Building Work Rectification Order

Section 33 of the Residential Apartment Buildings (Compliance and Enforcement Powers) Act 2020

Briens Rd Developments Pty Ltd (ACN 640 206 104) is being given this Building Work Rectification Order (Order) in relation to address 34-36 Briens Road, Northmead NSW 2152 (Lot 1 & B, DP 15342 & 320582) (the Development).

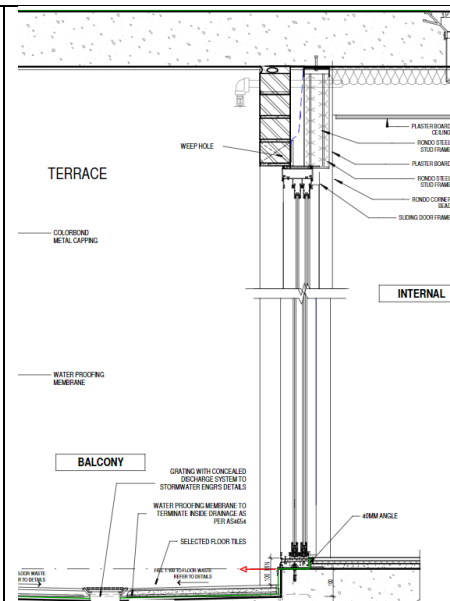
1.	Building enclosure Fire safety system	Awning windows have been installed instead of sliding windows	The approved plans provide for openable windows to be of the sliding type. The installation of awning windows may reduce the fire resistance of the building	<p>The installation of the incorrect window type demonstrates a failure to comply with the Fire Engineering Report No. 21160-R01 Issue No.4 from INNOVA Fire Safety Specialists. In summary of fire safety requirements item 2.2 Protection of openings in external walls, Protection of Openings in External Walls, it is stated:</p> <p><i>“1. The openings highlighted in Figure 1 to Figure 4, which will be located within 3 m of the side allotment boundaries, shall be protected externally with radiant heat attenuation screens. The required radiant heat attenuation screens over the fixed / operable parts of the openings shall be tested up to an irradiance of 40 kW/m² in accordance with Appendix B7 of AS 1530.4-2014 to reduce the radiant heat flux on the non-fire side of the opening to at least 40% of received radiant heat for a period of at least 1-hour, when tested to AS 1530.4-2014.</i></p> <p>Notes:</p> <ul style="list-style-type: none"> ▪ All windows protected with radiant heat attenuation screens can remain openable. 	During a fire, fire and smoke could spread in an uncontrolled way throughout the building

<p>The Developer is to ensure the following building work is carried out:</p> <ol style="list-style-type: none"> 1. Sliding windows are installed instead of awning windows to bedrooms located within 3m of side allotment boundaries, in accordance with Fire Engineering Report No. 21160-R01 Issue No.4 from INNOVA Fire Safety Specialists dated 2 March 2022. 2. Rectify any consequential damage.

<p>Architectural Plans issue for construction issue 1, Drawing 315 shows a door (D20) located on the right side of the window (W03) to the kitchen wall.</p> 	
--	--	--	--	---	--

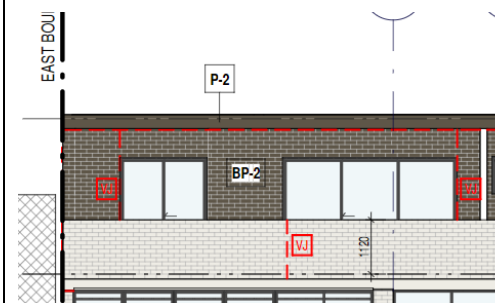
3.	Building enclosure	A door to the balcony has not been installed consistent with the approved plans	The approved plans provide for a door located in the kitchen. This has not been installed	Architectural Plans issue for construction issue 1, Drawing 315 shows a door marked (D20) located on the left side of the window (W03) to the kitchen wall. Drawing 801, Door schedule indicates D20.	Residents cannot access the balcony from within the unit and must go outside to access the balcony

3.	Level 3 Units 301 and 303	A door to the balcony has not been installed consistent with the approved plans	<p>The Developer is to ensure the following building work is carried out:</p> <ol style="list-style-type: none"> 1. The door included on the approved plans is installed. <p>Alternatively:</p> <p>The Developer is to take the following specified action:</p> <ol style="list-style-type: none"> 1. Ensure the building practitioner obtains a regulated design and design compliance declaration for the building element prepared by a registered design practitioner. 2. Ensure the building practitioner or appropriate practitioner to lodge the regulated design and design compliance declaration on the NSW Planning Portal in the approved way prior to commencing building work. <p>The Developer is to ensure the following building work is carried out:</p> <ol style="list-style-type: none"> 1. Install doors to balcony as provided for in approved plans and in accordance with the regulated design. 2. Rectify any consequential damage. 	2 months

<p>And drawing titled “ELEVATIONS” ref 500 dated 15/12/21 rev 2 by ZHINAR Architect which provides:</p> <p>And approved plan titled “DOOR SCHEDULE” ref 801 dated</p>	<p>performance of the façade</p>
--	--	--	--	---	----------------------------------

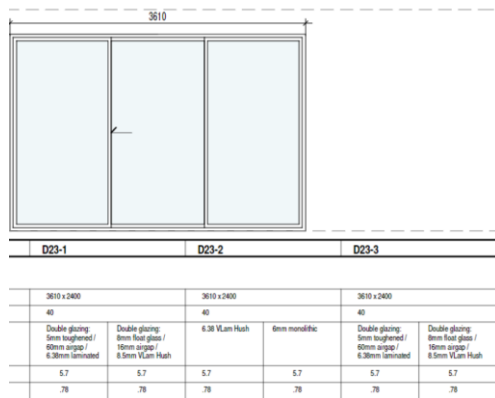
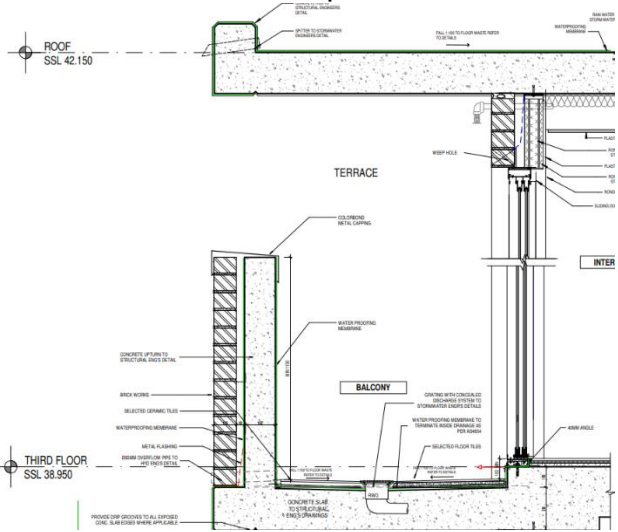
5.	Building enclosure	Sliding doors installed measure 2880mm in height	The approved plans show sliding doors at 2400mm height with brickwork above the window head.	The failure to install the appropriate sliding doors demonstrates a failure to comply with the approved plans Elevation Drawing titled “DETAIL SECTIONS” ref 570 dated 15/12/202 rev 2 by ZHINAR Architect which provides:	Construction not in accordance with the approved plans could lead to water ingress, reduced thermal performance of the facade and reduced acoustic

5.	All balcony sliding doors	Sliding doors installed measure 2880mm in height. The approved plans show sliding doors at 2400mm height with brickwork above the window head.	<p>The Developer is to ensure the following building work is carried out:</p> <ol style="list-style-type: none"> 1. The balcony door construction is in accordance with the approved plans, including a door height of 2400mm with brickwork above the window hand. <p>Alternatively:</p> <p>The Developer is to take the following specified action:</p> <ol style="list-style-type: none"> 1. Ensure the building practitioner obtains a variation to the regulated design and design compliance declaration for the building element prepared by a registered design practitioner. 2. Ensure the building practitioner or appropriate practitioner to lodge the regulated design and design compliance declaration on the NSW Planning Portal in the approved way prior to commencing building work. <p>The Developer is to ensure the following building work is carried out:</p> <ol style="list-style-type: none"> 1. Install the door per the approved plans and in accordance with the regulated design. 2. Rectify any consequential damage. 	3 months

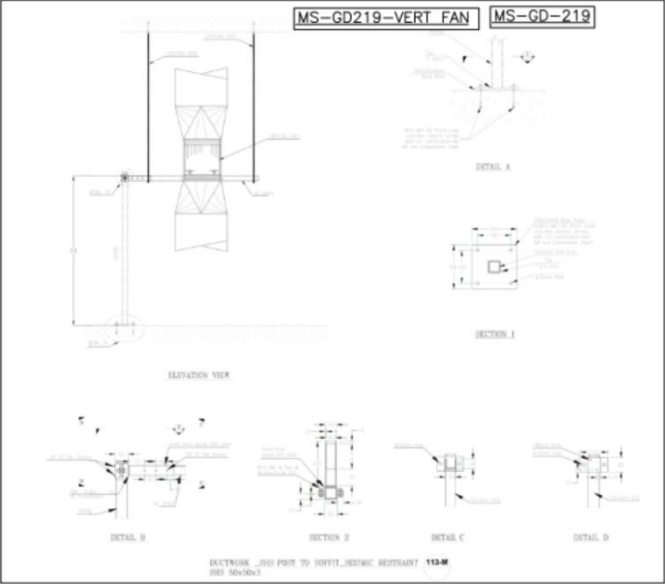
9.	Plumbing services	The linear drain is not installed in front of the lift landing opening and is inadequate in size to prevent surface water entering the lift shaft.	The inadequate drain may allow water to penetrate into the lift shaft	<p>The inadequate drain demonstrates a failure to comply with the BCA 2019 Volume 1 Amendment 1, performance requirements FP1.3 and FP1.4. FP1.3 Rainwater drainage systems, which states: “A drainage system for the disposal of surface water resulting from a storm having an average recurrence interval of —</p> <ul style="list-style-type: none"> (a) 20 years must — (i) convey surface water to an appropriate outfall; and (ii) avoid surface water damaging the building; and (b) 100 years must avoid the entry of surface water into a building.” 	Water could penetrate into the lift shaft, damaging machinery

further and ultimately the ductwork may collapse.
11.	Electrical services	The main switchboard main switches are not accessible	A key is required to open the panel to the main switchboard. In order to operate efficiently during an emergency, the main switchboard should be easily accessible.	The inaccessible switchboard demonstrates a failure to comply with AS/NZS 3000:2018 clause 2.3.3.4 (a) which states: <i>"Main switches shall be accessible as follows: (a) General Main switches shall be readily accessible and the means of operating such switches shall be not more than two meters above the ground, floor or a suitable platform."</i>	During an emergency, efficient operation of the main switchboard may not be available.

10.	Mid-level basement grid line B-04	The car park exhaust duct has inadequate support for the size and weight of the duct	Ensure the duct has adequate support consistent with its size and weight	<p>Within the time period specified in column 6,</p> <p>Stage 1 Submit a written report to the OC Audit team via email to ocaudits@customerservice.nsw.gov.au</p> <p>The written report required to be submitted must:</p> <p>i) be prepared by a suitably qualified and experienced person or specialist appropriate to the</p>	<p>Stage 1: 1 month</p> <p>Stage 2: 2 months</p>
